PLEASANT VALLEY ROAD / I-77 SB RAMP
/ FORESTWOOD DRIVE INTERSECTION
'BUILD ALTERNATIVE 1'
SHEET 1 OF 3

PLEASANT VALLEY ROAD / I-77 SB RAMP / FORESTWOOD DRIVE INTERSECTION 'BUILD ALTERNATIVE 2'

FIGURE 8

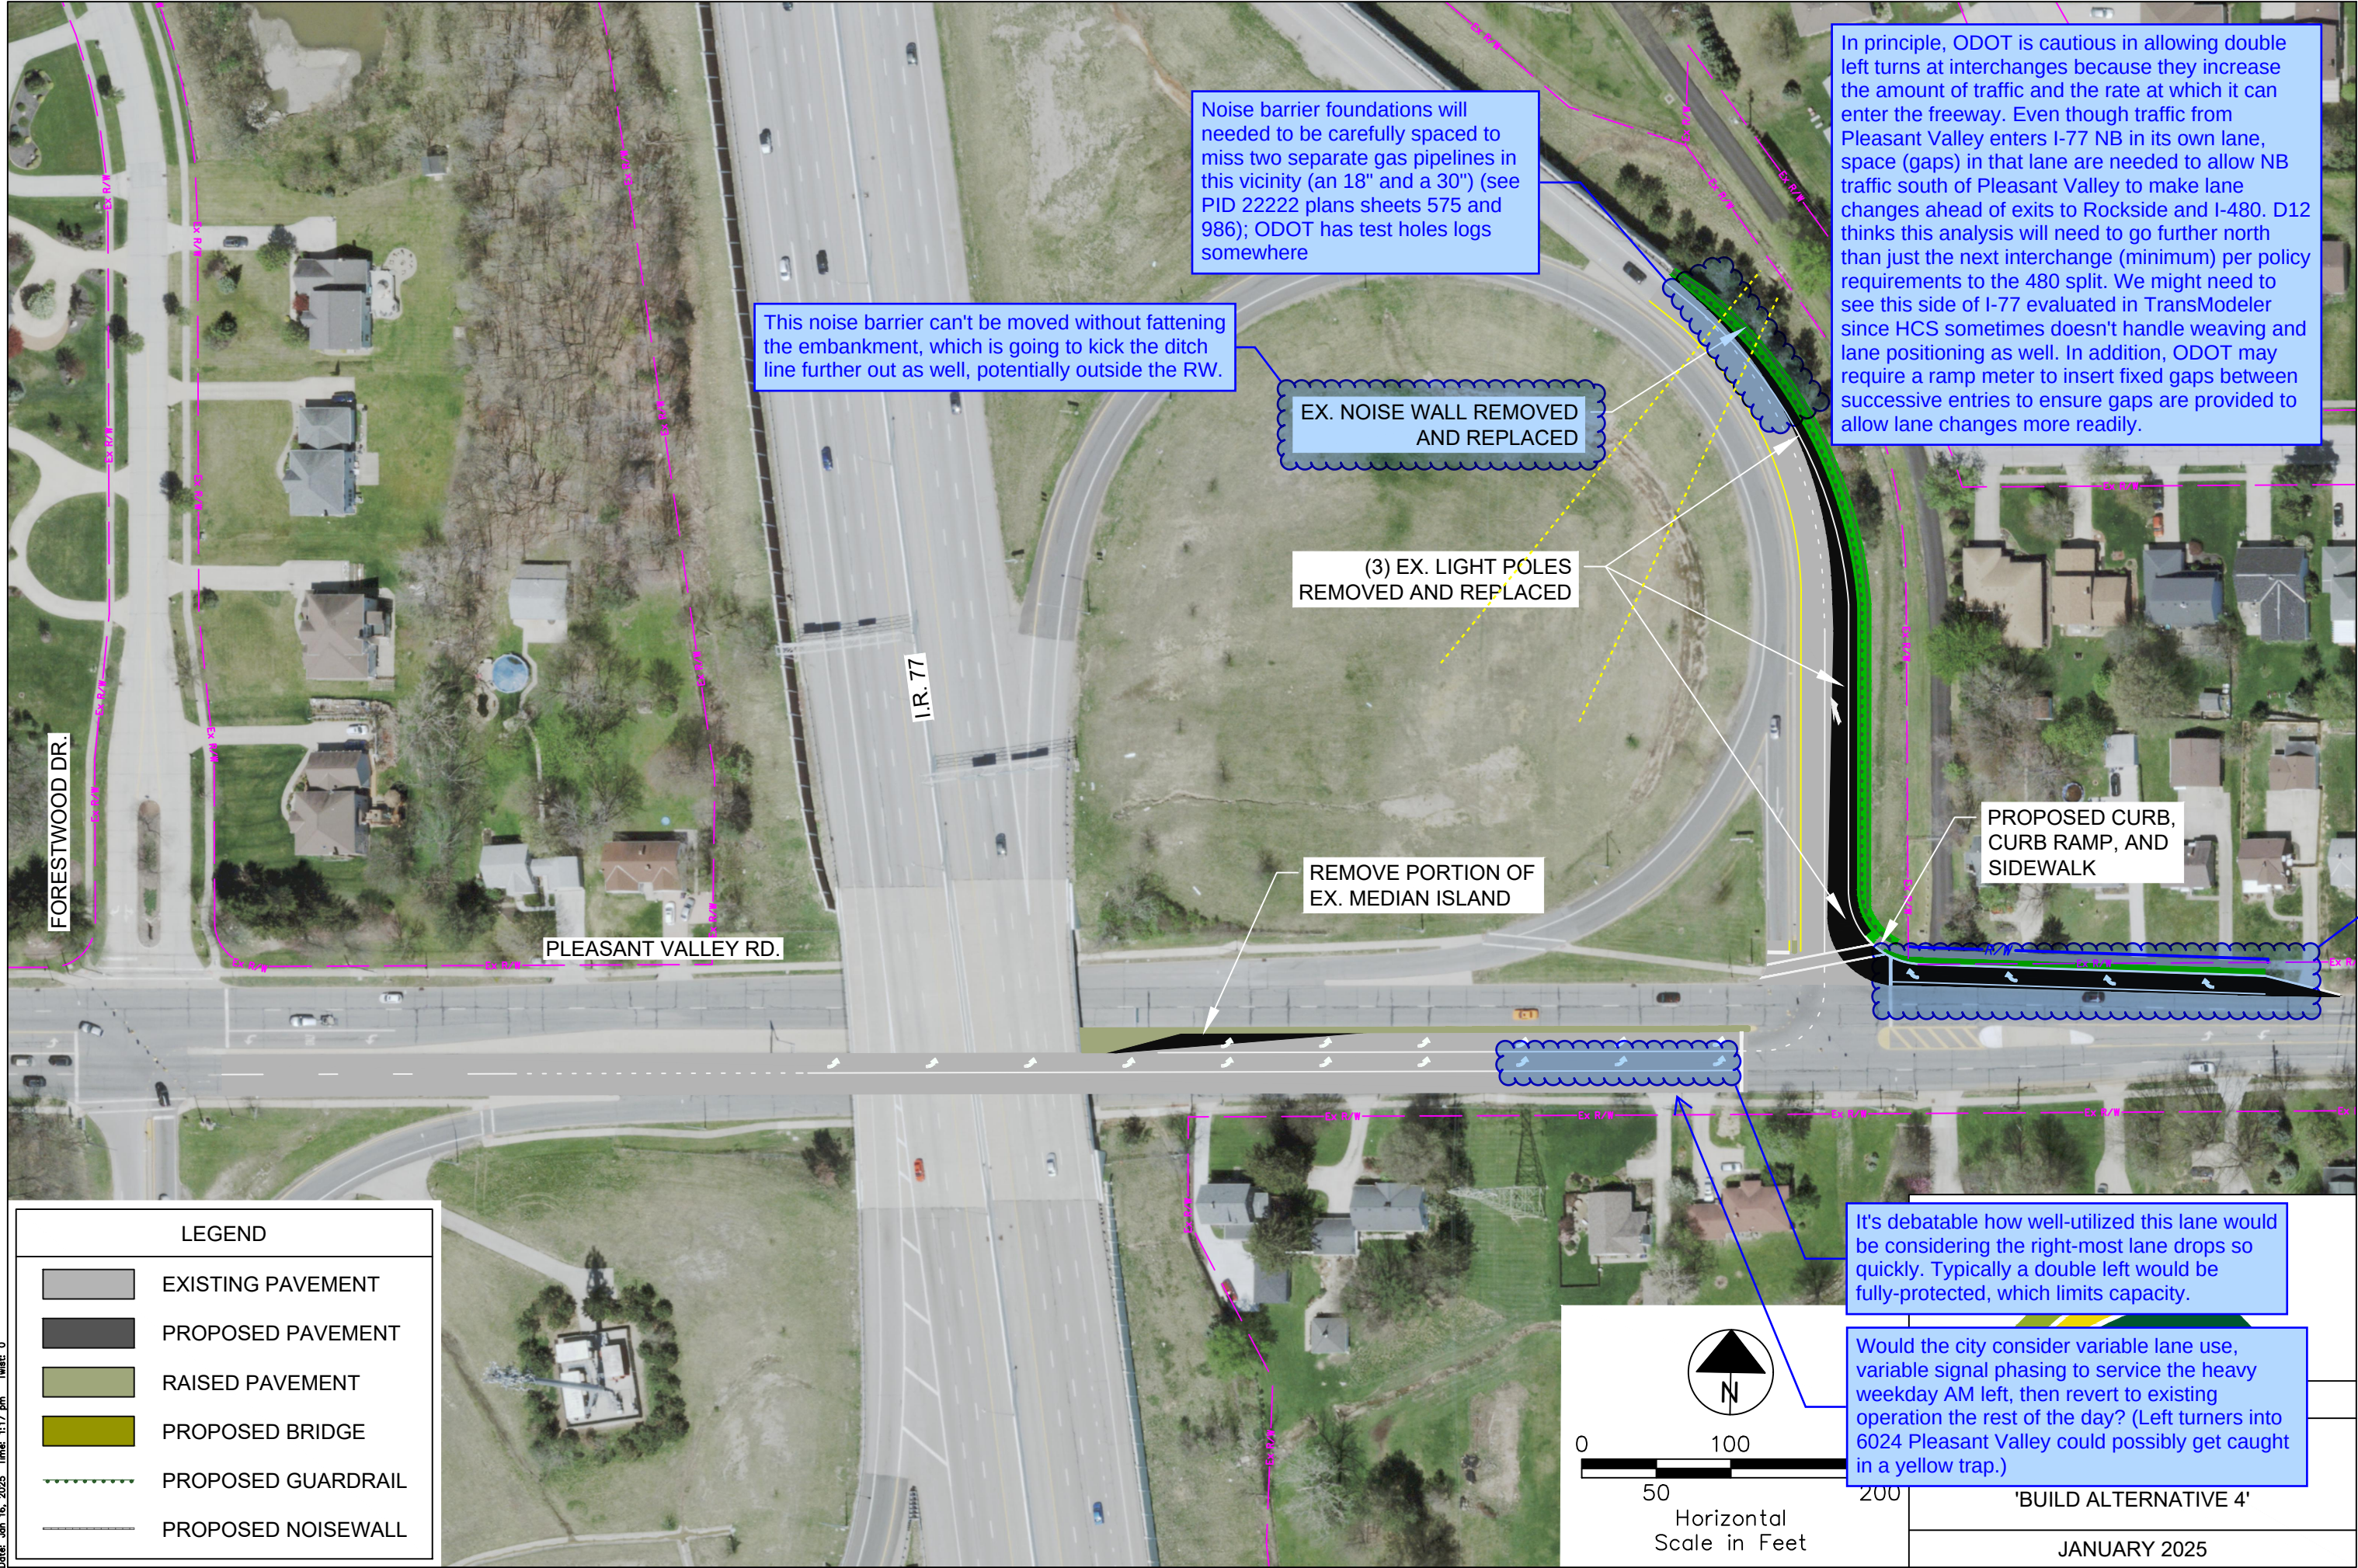
he is practically
the EB left turn
e, why not just
far side of the
the taper? I
drop people into
considering the
ould do worse...
we could get by
(through the NB
of the SB exit.
ks promising.

FIGURE 10

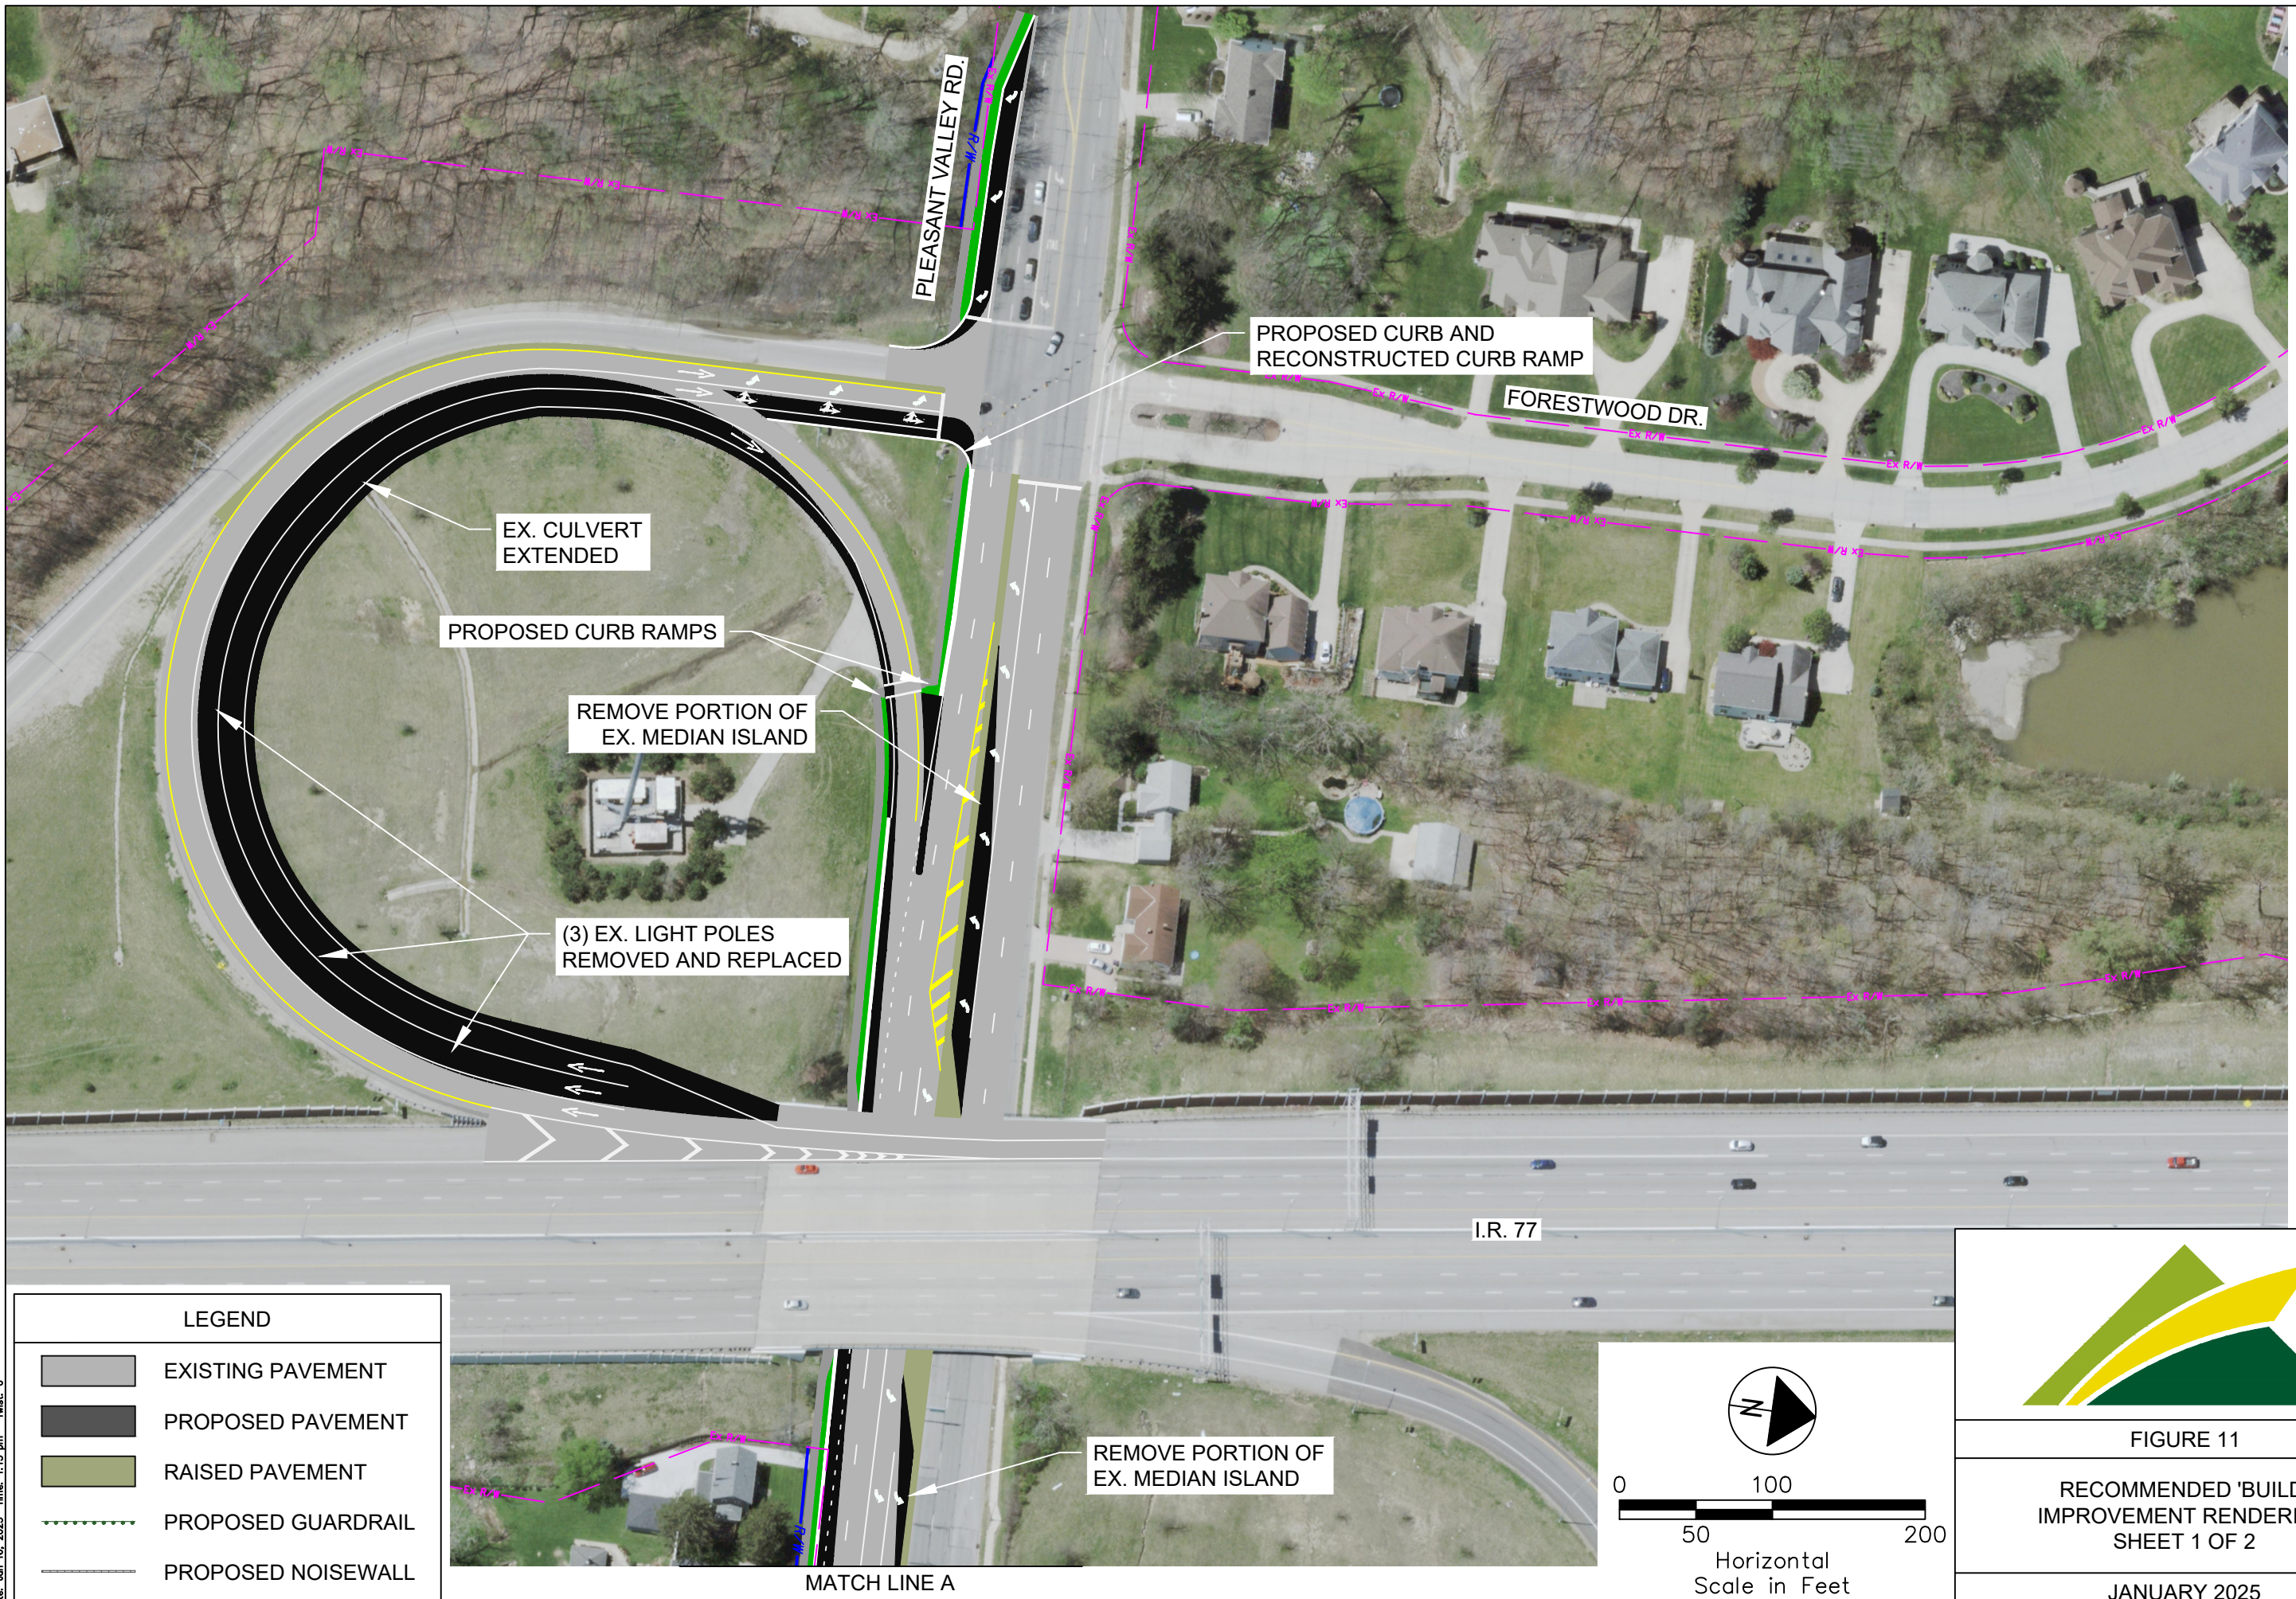
Red dotted line looks like a project of the
centerline of Pleasant Valley Road. Aren't the
pier columns along the centerline inside the
raised concrete median? What's going to be
the offset to the toe of the barrier needed to
protect them, assuming it will be less than 4'?

Need a section here to see what
this is going to look like to confirm
ODOT bridge engineers would be
OK with the treatment. One
possibility would be to do
something similar to Rockside
under I-77, using barrier wall to
retain part of the spill-through slope.
